Subject: Phillips 66 Company Propane Recovery Project FEIR

Bay Area Air Quality Management District (Air District) staff has reviewed the County's Final Environmental Impact Report (FEIR) prepared for the Propane Recovery Project (Project) located at the Phillips 66 Refinery in Rodeo. The Project proposes constructing and operating new facilities to recover propane from refinery fuel gas and increase the volume of butane for sale off-site. Staff appreciates the County's responses to the issues raised by the Air District in its August 6, 2013 letter and has the following comments.

Chart S-2. Copy of DEIR Figure 3-6. "Proposed Refinery Fuel Gas Block Flow Diagram." Stream "RFG-A" (bottom right) bypasses LPG project components (yellow boxes).

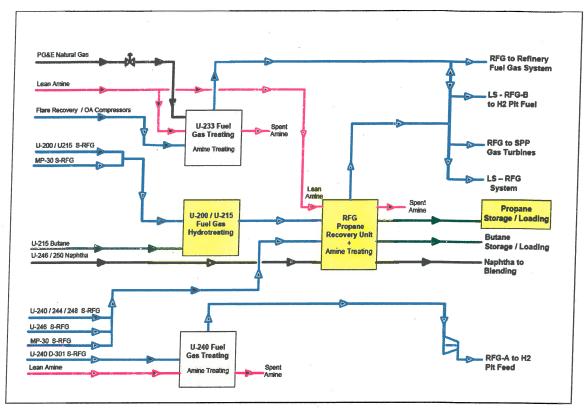
The summary values Phillips reports include streams from which the project the EIR describes would not recover LPG and thus do not represent baseline conditions for analysis. For example, this "summary of those measurements" Phillips reports includes "[p]ropane and butane obtained from two refinery fuel gas streams: U233 and RFG-A." However, the project as described in the EIR does *not* include LPG recovery from the "RFG-A" stream. See DEIR Figure 3-6, reproduced in Chart S-2 below.

The RFG-A stream is shown in blue at the bottom right, going to "H<sub>2</sub> Plt Feed," and the proposed project's LPG recovery is the central yellow box in DEIR Figure 3-6. The Figure shows RFG-A *bypassing* project recovery to become hydrogen plant feed. As described in the EIR, the project would not recover LPG from RFG-A.

Propane, butane, and flow volumes for each stream reported in Exhibit 1-A of Phillips' Response (Staff Report Exhibit #7) are reproduced in Table S-2 below. When RFG—A is excluded consistent with the EIR project description, the only stream that is not already recovered for sale is the U233 fuel gas stream. Phillips' Response reports this stream (U233) contains  $\approx$ 2,388 barrels/day of propane and  $\approx$ 2,839 b/d of butane. These

values (2,388 b/d propane; 2,839 b/d butane) are much smaller than the 4,200 b/d of propane and 3,800 b/d of additional butane that the EIR states the project would be designed to recover.<sup>8</sup> Thus, based on the evidence provided in Phillips' Response and project description in the EIR alone, one would be forced to conclude that LPG recoverable in the project baseline is *insufficient* to implement the project's stated goals.
